Access Compliance Report Public Rights-of-Way (Curb Ramps)

Main Street: N/A Cross Street: AVENIDA LA PATA Location: S

ADA ID: RPRK211201122730 Ramp Type: Type 1 - Perpendicular Diagonal Initial Pass/Fail: Fail Overall Compliance: No Severity Score: 2

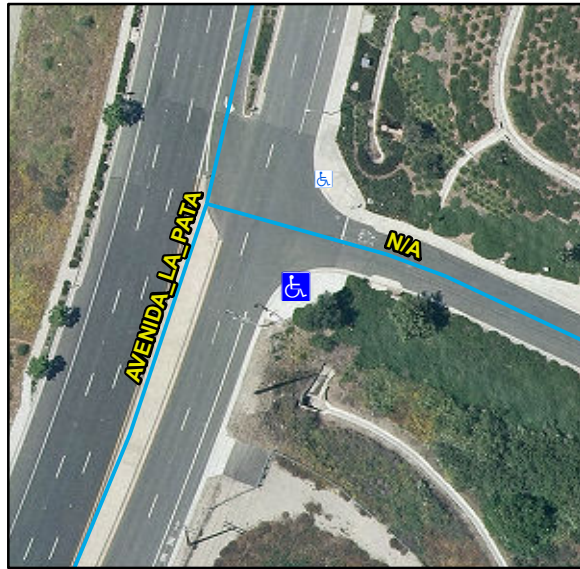
Compliance	Description	Data	Compliance	Description	Data
N/A	Ramp Length (in)	138	N/A	Flare Type LT	
Yes	Ramp Width (in)	48			N/A
Yes	Ramp Run Slope (%)	7.4	N/A	Flare Slope LT (%)	N/A
No	Ramp Cross Slope (%)	2.6	N/A	Flare Traversable LT	N/A
N/A	Landing Present	N/A	N/A	Flare Type RT	
N/A	Landing Length (in)	N/A			N/A
N/A	Landing Width (in)	N/A	N/A	Flare Slope RT (%)	N/A
N/A	Landing Run Slope (%)	N/A	N/A	Flare Traversable RT	N/A
N/A	Landing Cross Slope (%)	N/A	N/A	DWS Provided	N/A
N/A	Landing Movement Obstructed?	N/A	N/A	DWS Contrast	N/A
	Landing Movement Type	N/A	N/A	DWS Length (in)	N/A
N/A	Landing Shared	N/A	N/A	DWS Full Width	N/A
N/A	Clear Space	Yes	N/A	DWS Offset Left (in)	N/A
N/A	Clear Space To Crosswalk (in)	N/A	N/A	DWS Offset Right (in)	N/A
N/A	Marked Crosswalk 1	No	N/A	Marked Crosswalk 2	No
	Crossing 1 Direction	N		Crossing 2 Direction	W
	Marked Crosswalk 1 Width (in)	N/A		Marked Crosswalk 2 Width (in)	N/A

N/A	Ramp Inside Crosswalk 1	N/A	Yes	Ramp Inside Crosswalk 2	N/A
	Crossing 1 Slope (%)	0.2		Crossing 2 Slope (%)	8.3
	Crossing 1 Cross Slope (%)	3.7		Crossing 2 Cross Slope (%)	4
N/A	Gutter Ponding	N/A	N/A	Curb Slope	3.7
Yes	Gutter Lip Height (in)	0		Road Run Slope (%)	2.1
N/A	Gutter Run Slope (%)	N/A		Road Cross Slope (%)	5.1
N/A	Gutter Cross Slope (%)	N/A			
Yes	Overall Surface Condition: Acceptable		Yes	Perp Joint Present	Yes
	Cross Gutter Present?	No		Spandrel Present?	No
	Replace Cross Gutter?	N/A		Replace Spandrel?	N/A

Remove & Replace Curb Ramp With Two New Directional Ramps or Equivalent.

R304.5.3, STD 1115
